## **HISTORIC PRESERVATION BOARD**

### **HISTORIC PRESERVATION BOARD AGENDA** **May 7, 2014 – 5:00**

**SITE VISIT AND PUBLIC HEARING  
638 CONGRESS STREET**

**WORKSHOP (continued from 4/16)  
EVERGREEN CEMETERY**

CONGRESS STREET ELEVATION  
N.T.S.

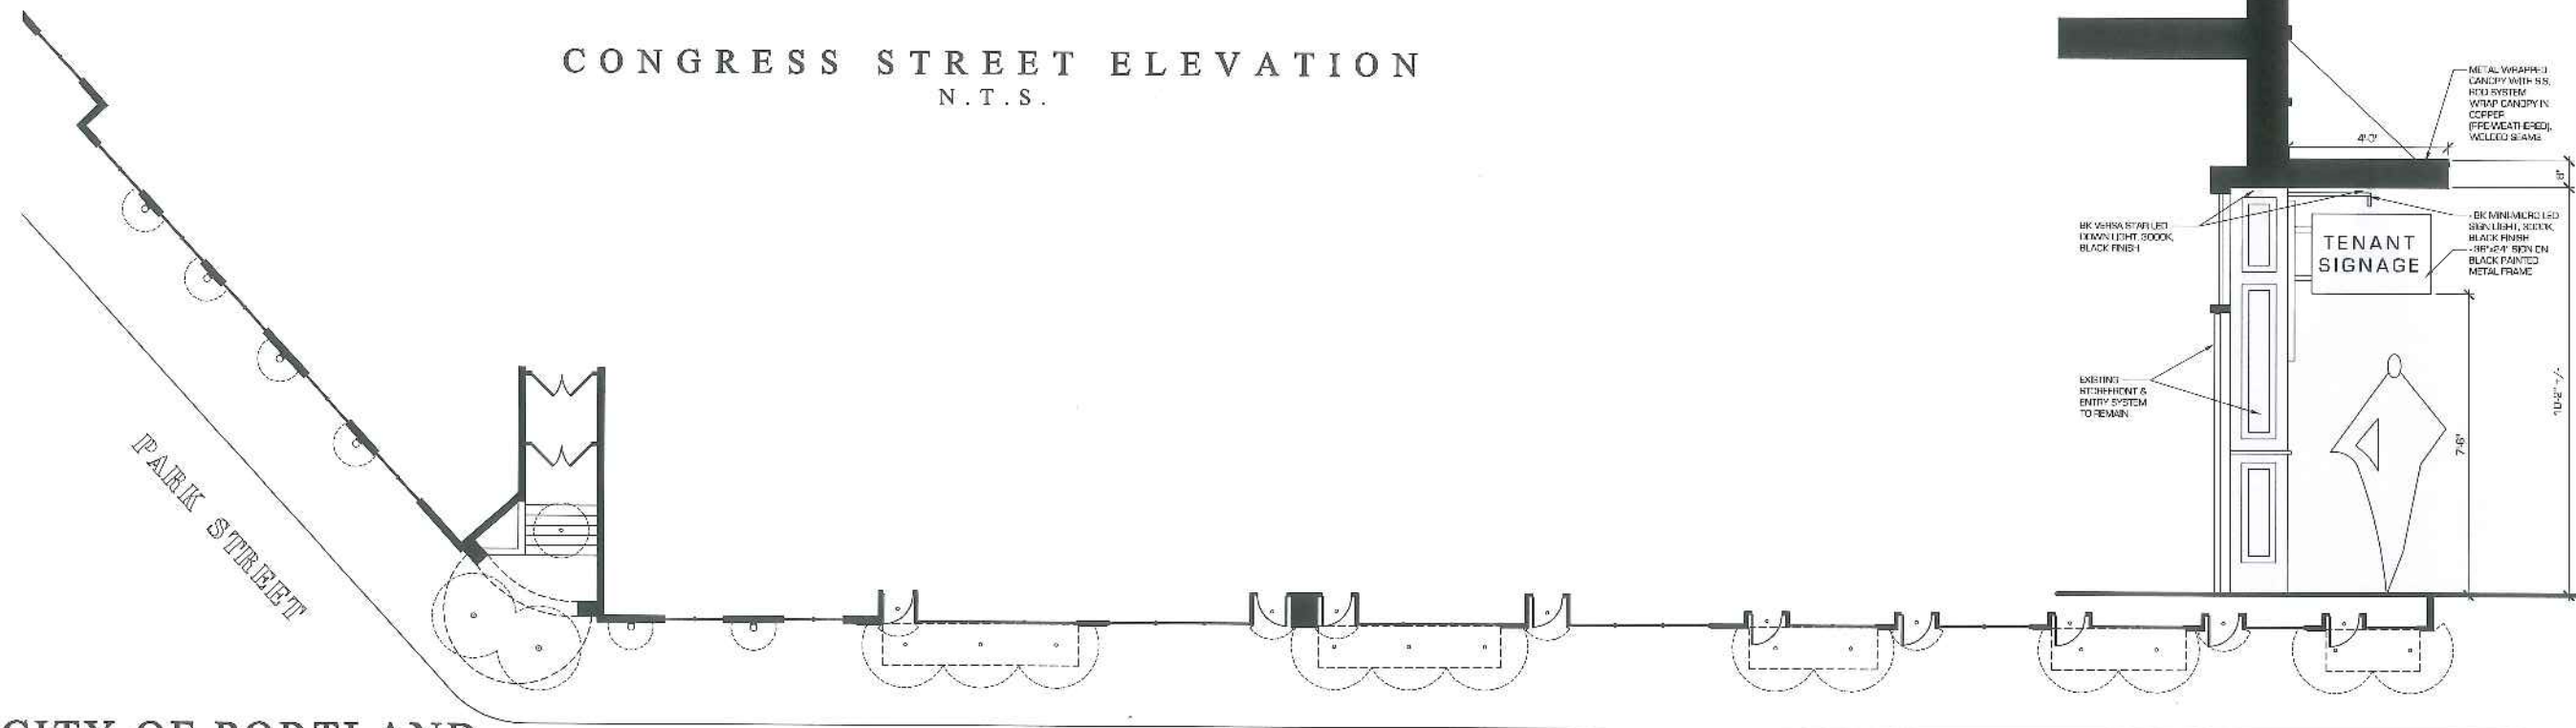
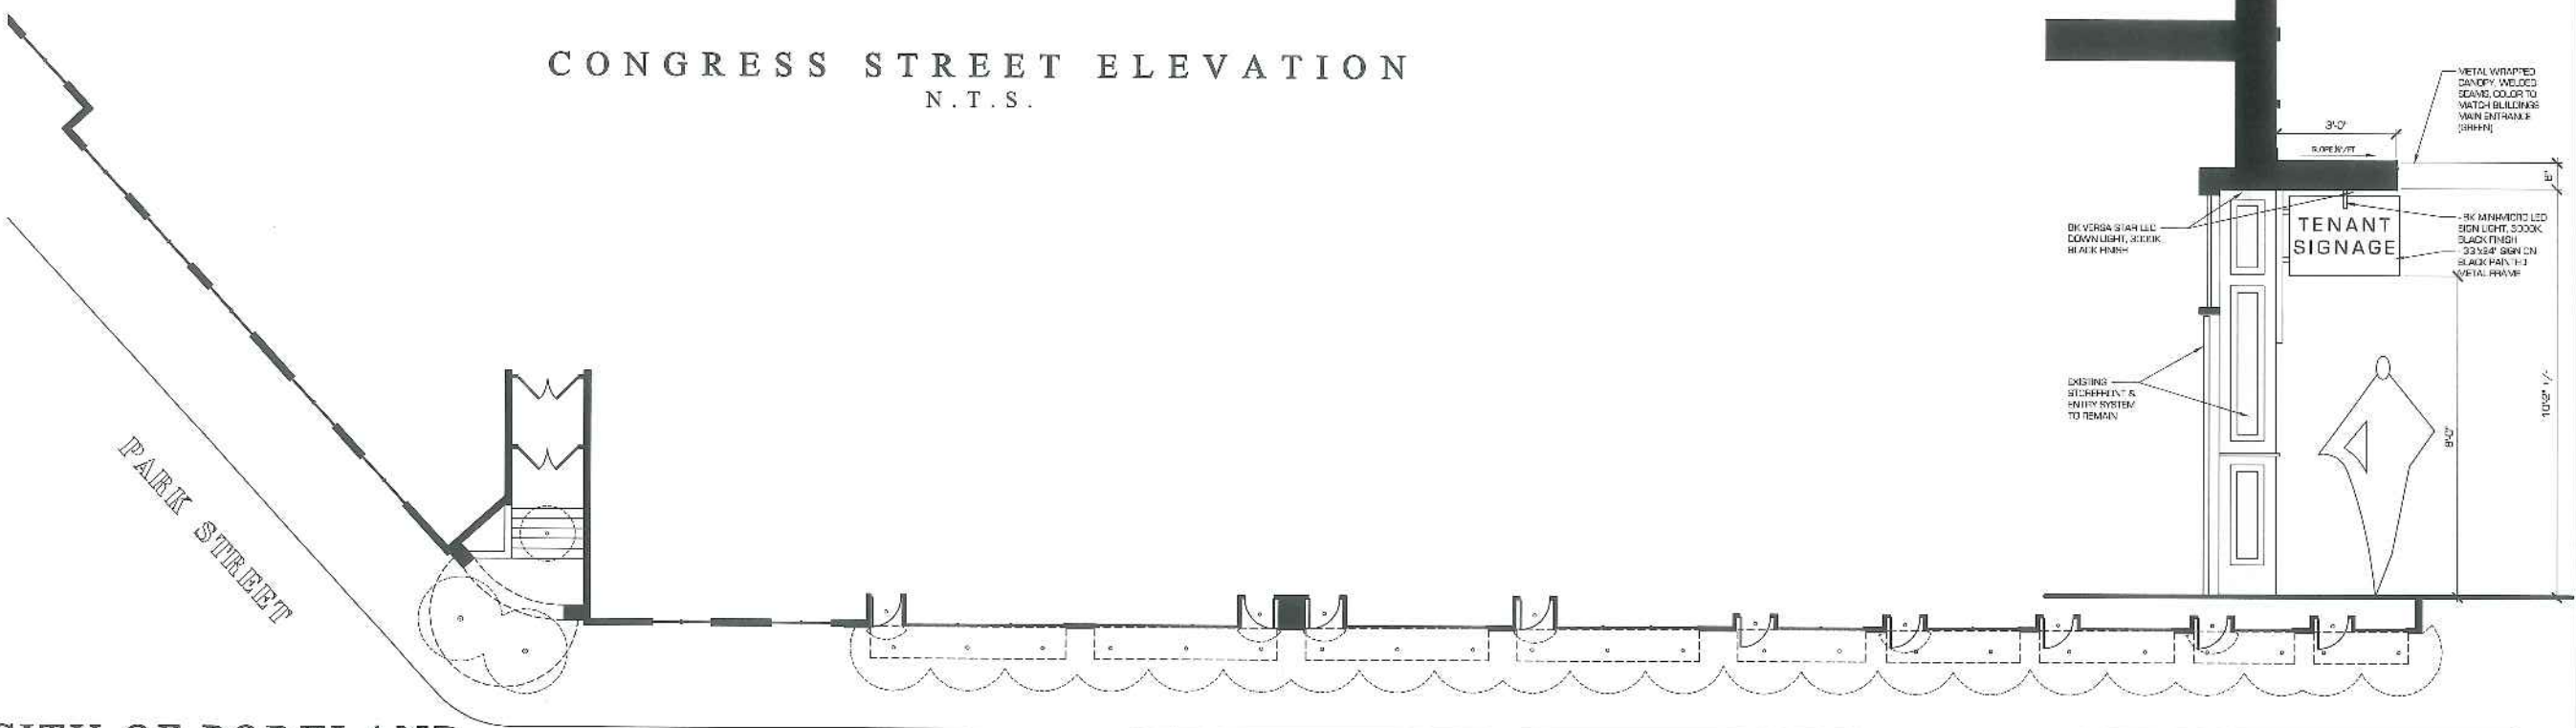
After extensive discussion the Board recommended eliminating all of the exterior wall sconces, instead urging the applicants to focus on the canopy lighting at the entrances. Lack of a consistent pattern in the ground floor façade elements makes fixture placement difficult. Large windows in the public lobby of the apartment complex should allow some intentional light spillage onto sidewalks, and frequent storefront canopy lighting on Congress Street can spread sufficient light to create desired effects, while drawing attention to the entrances.

Board members discussed the proposed storefront canopies at length, weighing the potential visual impact of the new elements, and how that might change with modifications of the program. The Board clearly desired a canopy over each store entrance, instead of the originally proposed pattern of one for every other bay. The awkward pattern of the gaps in the original proposal is magnified by the differing widths of the stores and their accompanying canopies. Although there was some ambivalence expressed about the new canopies, consistent addition of one over each store, and the suggestion that the new canopies should relate more closely to the existing apartment entrance canopy at the corner seemed to engender a generally positive disposition toward the

The height of the proposed canopies on the face of the building, and depth of the canopies' projection outward were perhaps the two most significant unresolved issues of the design, and the reasons for the May 7 site walk. There was agreement that the continuous frieze combined with the bands between the pilasters makes for a very wide horizontal space above the Congress street storefronts; several Board members suggested trying a higher position for the canopies, instead of the more traditional proposed position close to the tops of the storefront windows. There is hope the canopy mock-up will demonstrate whether raising the canopies can de-emphasize the width of the frieze and horizontal bands, or proves to create more awkward relationships between the façade elements. The architect noted that raising the canopies might place them uncomfortably far above the sidewalk and create too much space between the tops of storefront windows and the canopy soffits.

The Board also discussed whether the 4 foot depth of the canopies could be reduced to 3 feet to good effect. Mr. Provencal's proposal was based on an intuitive sense of the context; a mock-up should help the Board and the architect judge the most appropriate depth. At least one Board member expressed the hope that reducing the overhang to 3 feet could allow the elimination of cable supports tied to the building. A slight pitch outward will be necessary to drain the canopy roofs; no gutters or downspouts are proposed.

Mr. Provencal has submitted a revised drawing that shows changes inspired by the Board's comments.

1. No exterior wall sconces are now proposed.
2. A canopy is proposed for each of the Congress Street storefronts.
3. The canopy depth has been reduced to 3 feet, with no supporting cables.
4. The color of the canopies is proposed to match the color of the canopy at the main corner entrance for the apartments.

feedback, and the architect's revised April 29 drawing incorporates significant modifications to the proposal. Staff believes the Board is likely to be more comfortable with the consistency offered by adding a canopy to each storefront, while the depth of only 3 feet may or may not feel scant on a building with the Lafayette's scale. As with the depth, the appropriate height for the canopies will, it is hoped, be more easily decided after viewing the mock-up. The Board may wish to examine whether any changes besides the paint color might be incorporated to create a stronger connection between the existing entrance canopy at Park and Congress Streets and the proposed canopies.

# EVERGREEN CEMETERY CONTEXT PLAN

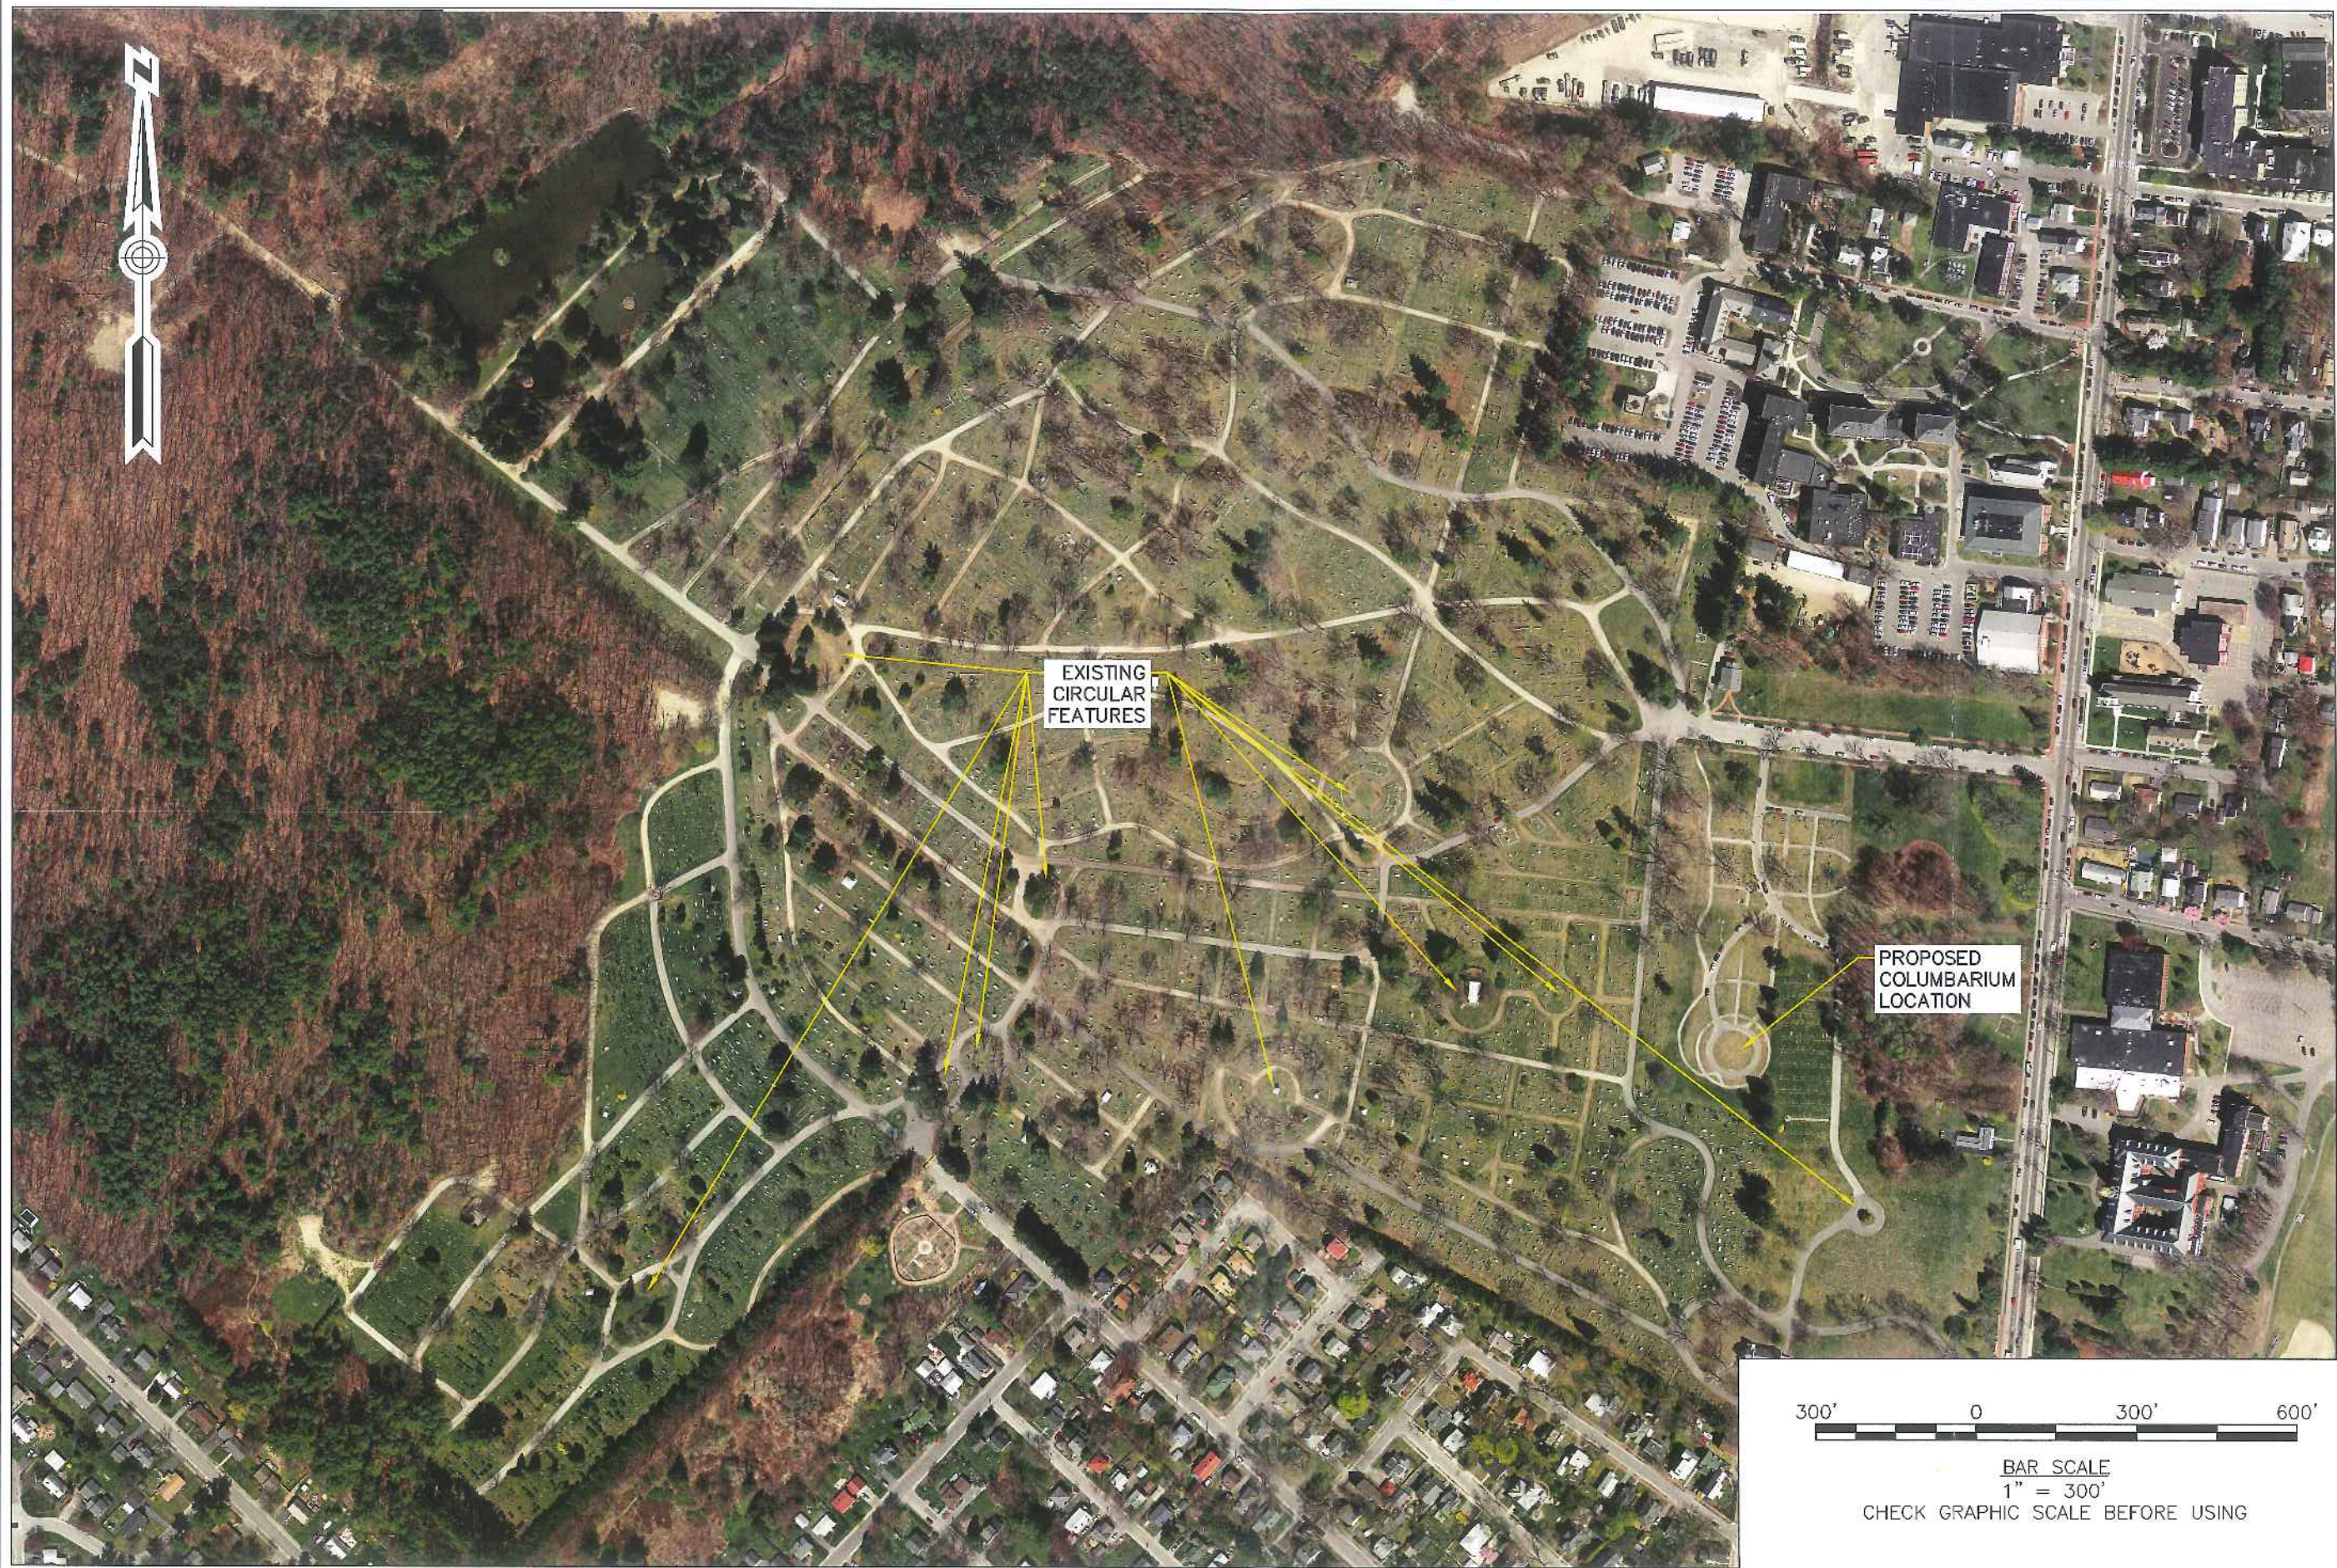
We understand that the Historic Preservation Board may have additional comments regarding the location of the columbarium relative to the circular roadway layout. We will be happy to discuss these comments further at the May 7 workshop, and to facilitate that discussion, we are presenting some additional information regarding the circular road layout.

The circle driveway is an existing feature that was approved and constructed as part of the Phase 1 expansion project. This circular feature is consistent with the overall road layout of Evergreen Cemetery, which includes numerous circular road intersections. Attached, please find a cemetery aerial photograph, which shows examples of similar circle features. Historic cemetery development frequently utilized circular roadway alignments, which were effective for large family plots and mausoleum construction. These burial options are not as common today.

The center of the existing circle does not provide an ideal space for layout and future maintenance of single plots, the cemetery's current market for burial options. The existing circle was selected as a suitable location for the installation of a new columbarium. We believe that the use of this space for a columbarium is appropriate based on our review of the 1994 Evergreen Cemetery Master Plan, in particular the following passage from the Cemetery Development section of the report's Analysis and Recommendations:

The columbarium and associated landscaping will provide both monumentation and planting to increase the visual impact of the circle. This previously underutilized space will contain 300 niches for the interment of cremation remains.

In the current cemetery layout, the Phase 1 expansion circle is essential because it provides both parking for vehicles during a funeral service and access for maintenance vehicles during interment. The proposed roadway widths are in keeping with the existing cemetery layout which has a mixture of road widths, including both 12-foot and 18-foot wide paved roads, matching the new roads.

We understand that the Historic Preservation Board may ask if the rear portion of the circle driveway could be eliminated, so that the columbarium is positioned closer to surrounding burial space. The Evergreen Cemetery staff has reviewed this suggestion in the field, and determined that the removal of the paved circle would isolate burial areas located south and west of the columbarium, creating significant challenges for delivery of the concrete vaults and interment equipment. There may be options for changing grades and adjusting layout to reduce the prominence of the proposed structure within the circle if that remains a concern.
